DSOX3034A-01

S E R V I C E N O T E

DSOX3034A – Oscilloscope, Mixed Signal, 4 Channel,
350MHz

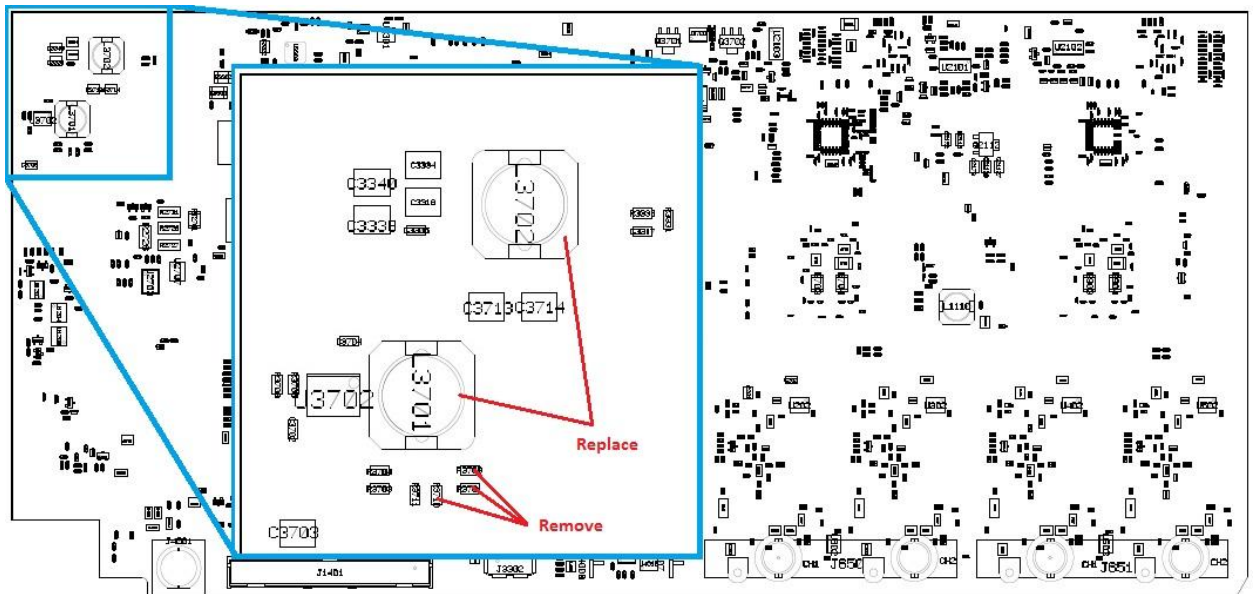
With the oscilloscope power turned on and while under normal operation, the unit emits a hissing noise.

2. As the picture indicates, remove the three resistors (0699-7209, 1 Ohm) located at R3701, R3709, and R3710. They are not to be replaced.
3. Remove as well the two inductors (9140-6474, 100uH) located at L3701 and L3702 and replace them with inductors with part number 9140-6151 (68 uH).
4. Re-assemble to the point where the unit could be powered up to verify that the hissing is indeed gone. If the hissing is not gone, please, check modifications.
5. When the hissing is gone, put oscilloscope back together.
